APPLICATION NO.	FILING DATE	FIRST NAMED INVENTOR	ATTORNEY DOCKET NO.	CONFIRMATION NO.
09/993,996	11/14/2001	Bernd Halbrock	65857-0037	8824

Office Action Summary

DETAILED ACTION

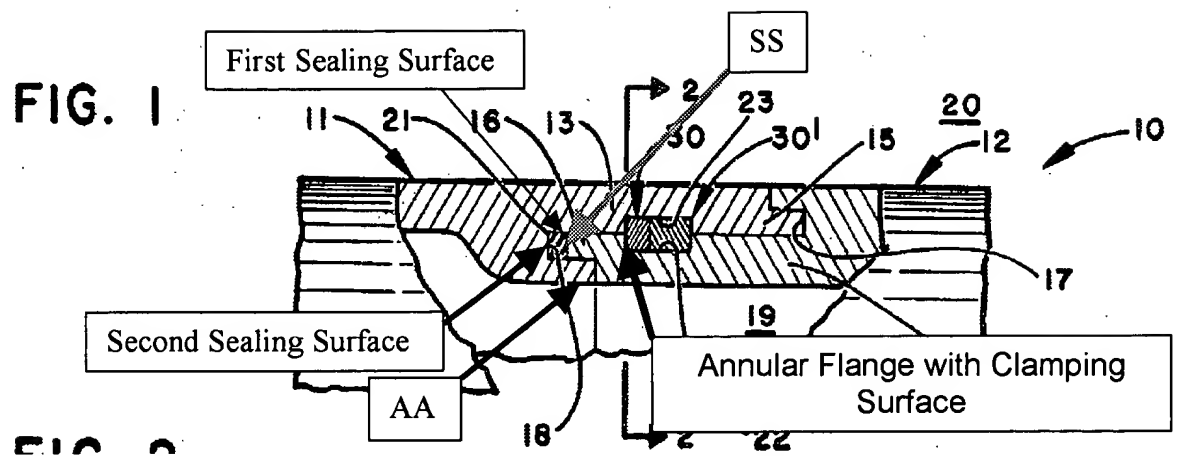
Claims 1, 15-23, 26 and 30-34 are rejected under 35 U.S.C. 102(b) as being anticipated by US patent 3600011, Alvis.

In regards to claim 1, Alvis discloses a quick-connect device for connecting fluid lines comprising:

a first connecting element (11) that includes an annular first support surface (AA), an inclined surface, and an annular receptacle space (18) with a first sealing surface and a second sealing surface,

an annular sealing element (21) that is arranged in the receptacle space and adapted to contact the first and second sealing surfaces,

a second connecting element (12) that includes a third sealing surface (SS) and an annular second support surface (16) adapted to contact the first annular support surface, and

a wedge-clamping device (30) that includes a clamping wedge adapted to contact the inclined surface of the first connecting element.

In regards to claim 22, in Figure 1 above, Alvis discloses the second connecting element including an annular flange with a clamping surface.

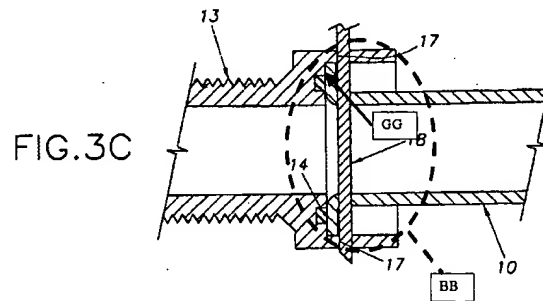
Claims 1, 15-23 and 25-34 are rejected under 35 U.S.C. 103(a) as being unpatentable over US patent 5513882, Lewis in view of US patent 3384393, Horton et al.

In regards to claim 1, Lewis discloses a quick-connect device for connecting fluid lines comprising a first connecting element (13) that includes an annular first support surface (16), an inclined surface, and an annular receptacle space (BB in Figure 3C

below) with a first sealing surface and a second sealing surface (inside of the groove holding seal 14), an annular sealing element (14) that is arranged in the receptacle space and adapted to contact the first and second sealing surfaces, a second connecting element (10) that includes a third sealing surface (SS) and an annular second support surface (12) adapted to contact the first annular support surface, and a

In regards to claim 26, Lewis discloses a support device (GG see Figure 3C above).
